## Product Change Notification

### MultiTech<sup>®</sup> Conduit<sup>®</sup>

## Updated Cellular Radio Firmware

PCN 07012020-001

**Cellular Radio Firmware Version Identification**

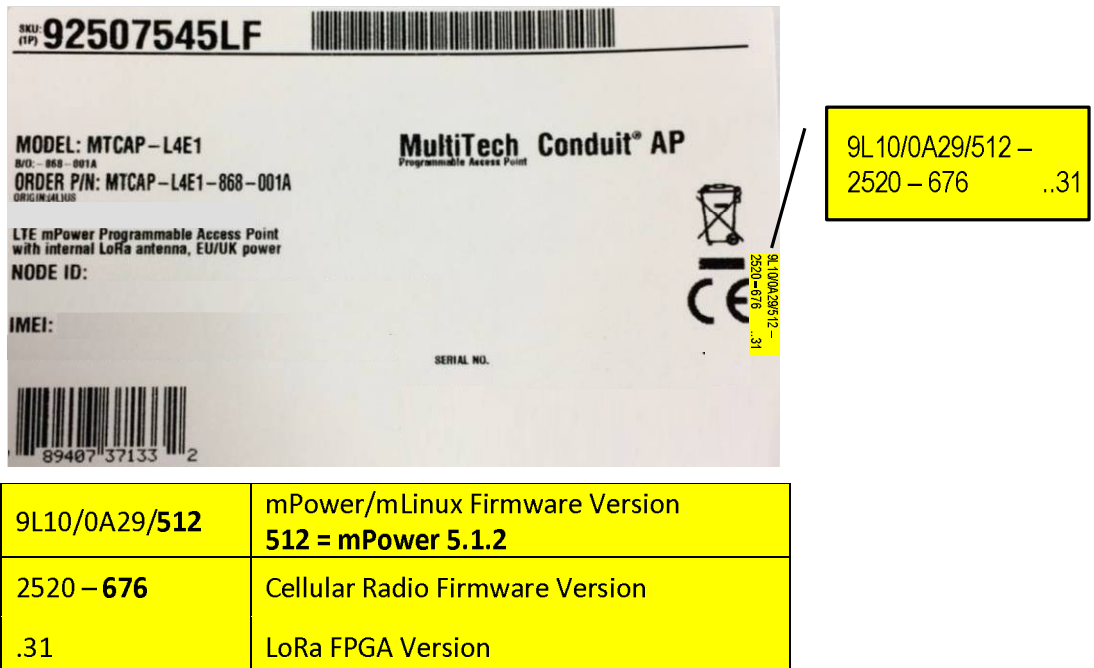
Cellular radio firmware version is identified on the single-pack and over-pack labels for each product as identified in the photo below.
